Department of Planning and Environment

Our ref: DOC22/551051

Subject: Shoalhaven LEP 2014 Moss Vale Road North Urban Release Area – Public Exhibition

Attachment 1: Flood Risk Management Comments, Moss Vale Road North URA

Figure 9: Moss Vale Road North Urban Release Area Riparian Assessment (Ecological, 27th April 2022)

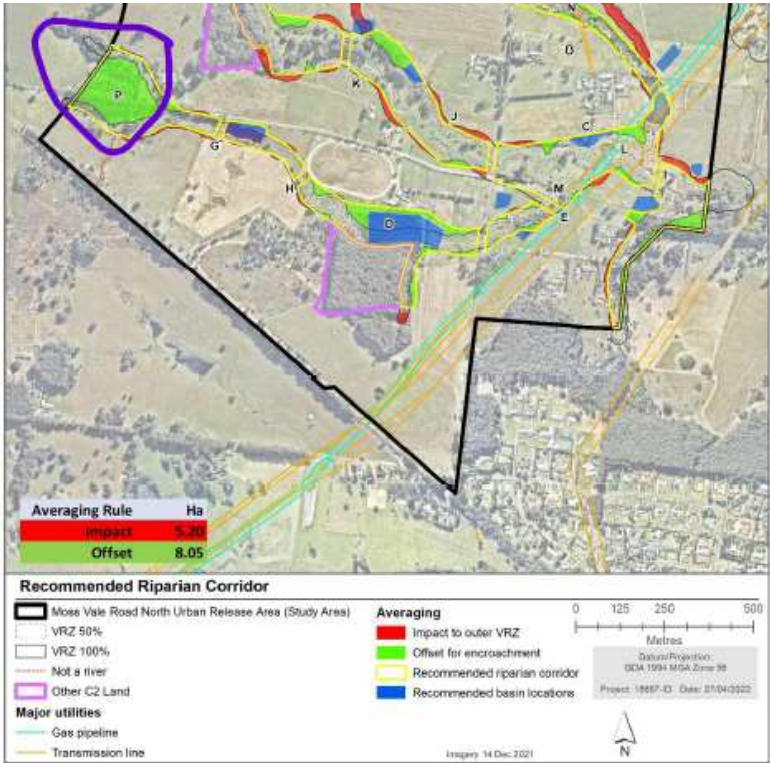
- The western riparian “offset for encroachment” area is also proposed to be zoned as R5 which appears incompatible (Figure 9 of the *Moss Vale Road North Urban Release Area Riparian Assessment (Ecological, 27th April 2022, see extract below)*).
- The North Eastern watercourse diversion appears to be relied upon as justification to remove the downstream riparian corridor.
 - As this area diversion is outside of the site extents, the long-term flood and riparian implications of relying on this diversion should be considered
 - If this diversion is formalised the watercourse stream order should be reviewed to account for this.

Figure 5: Indicative Layout Plan

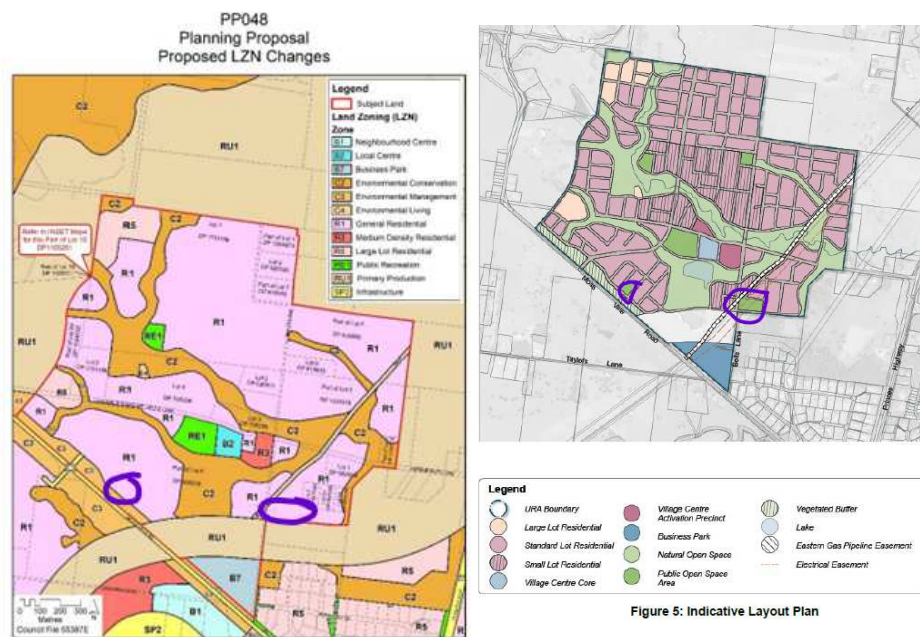
Additionally, the Indicative Layout Plan (ILP) should ensure all vegetation in the eastern area marked with purple highlighter, (Attachment 2), be protected and zoned for environmental conservation. Currently, vegetation as seen in the aerial image and the ILP does not correlate. Also, maps with an aerial underlay would be more informative. We also question why the zoning map continues to show this eastern patch of vegetation as R1 zone? Similarly, another park to the west of this patch is also in an R1 zone (also marked with purple highlighter on Attachment 2). This park should be zoned appropriately and the consistency between the ILP and the proposed zoning maps checked and rectified as necessary.

We question why the proposed zoning map does not include the two parks marked in purple highlighter?
